Work Order ID 157418

Item Name: Strut

ENGINEERING CHANGE NOTICE NO.

DWG TITLE: STRUT

SHEET 1, ZONE A1 IS:

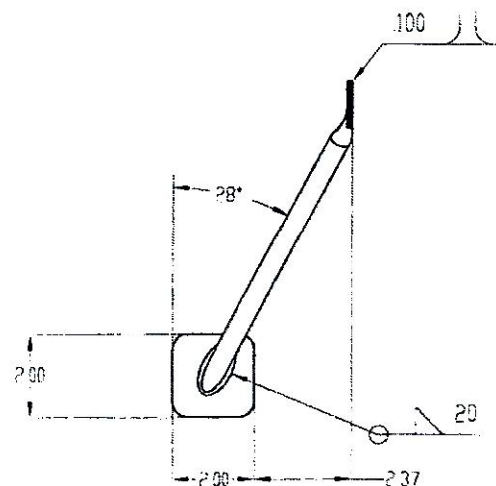
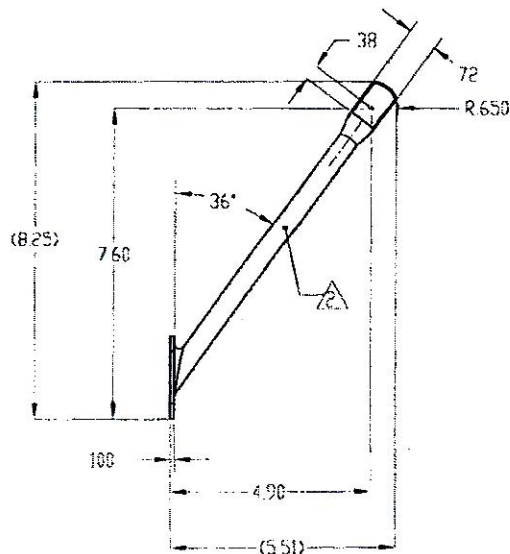
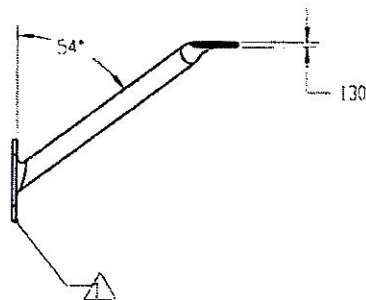
REASON: REVISED DELTA NOTE 1 & 2.

- 1 MATERIAL: AISI 304/ 316 SS SHEET .062 THK
(REF DART SPEC. M304S16GA)
- 2 MATERIAL: AISI 304/316 SS 0.500 OD X 0.049 WALL
(REF DART SPEC. M304TRO.500WO.049)
ENSURE SEAMLESS TUBE IS USED
- 3 FINISH: HARD ANODIZE IAW MIL-A-8625 TYPE III, CLASS 2
COLOR BLACK;
CARDINAL 4860-50 PRETREATMENT PRIMER
PRIME IAW MIL-P-23377J TYPE I CLASS N
4. DEBURR AND BREAK ALL SHARP EDGES
5. WELDS IAW MIL-STD-2219.
TIG WELD WITH FILLER ROD

SHEET 2, IS:

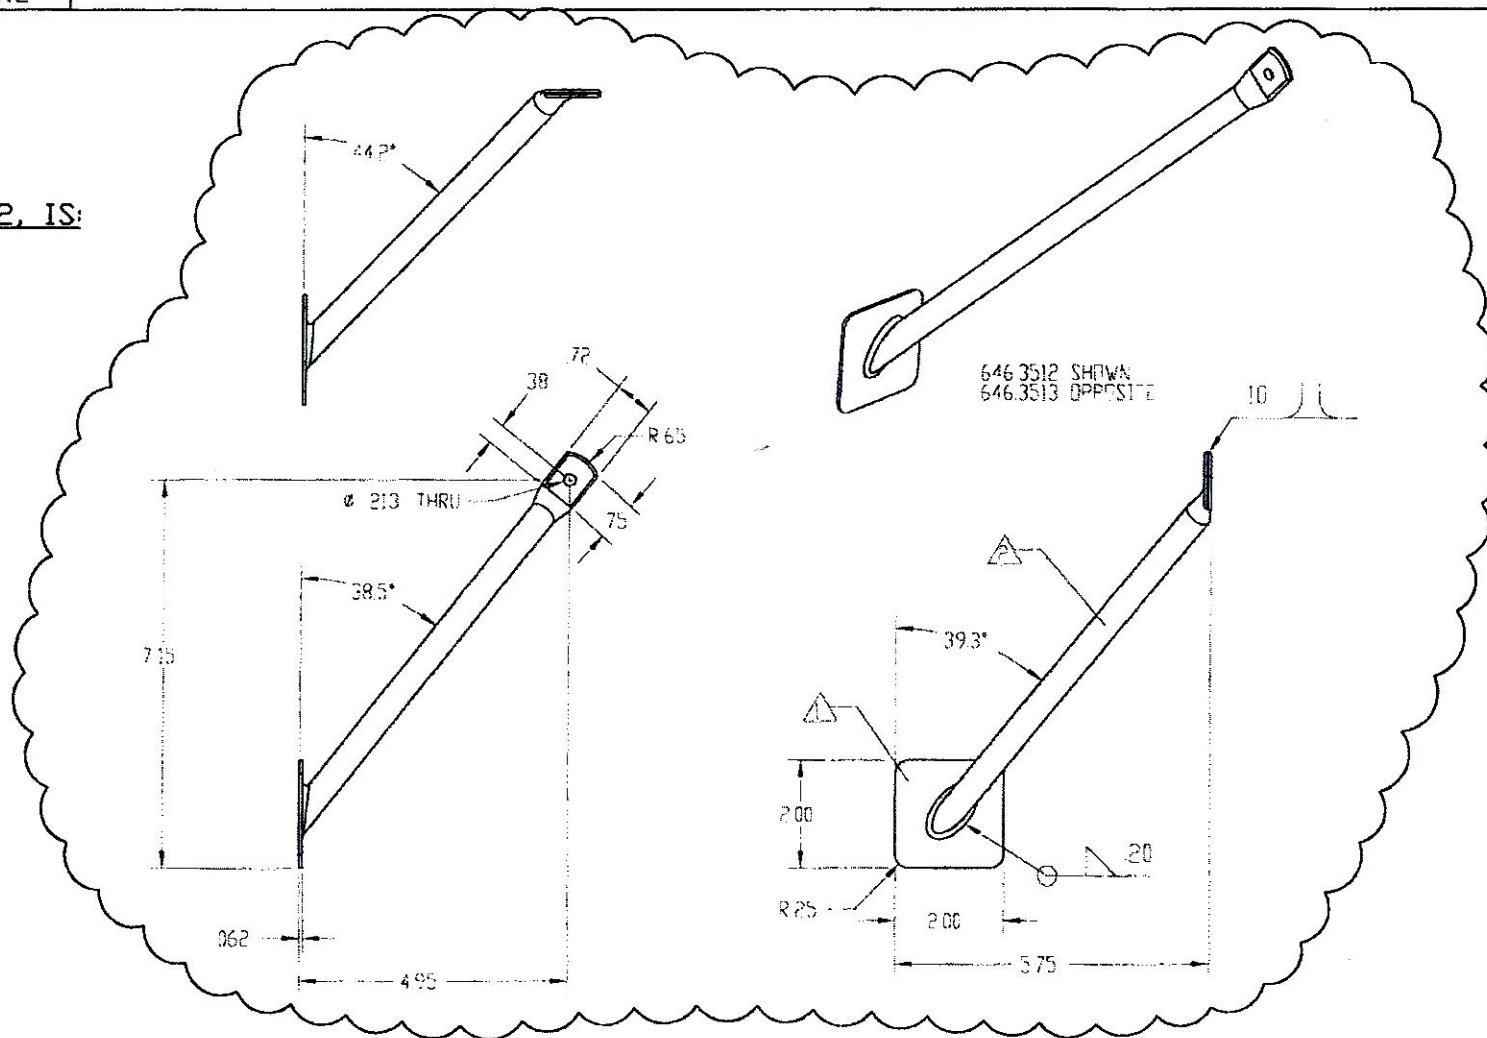
REASON: REVISED ANGLE OF 646.3512 & 646.3513 FOR BETTER FITMENT
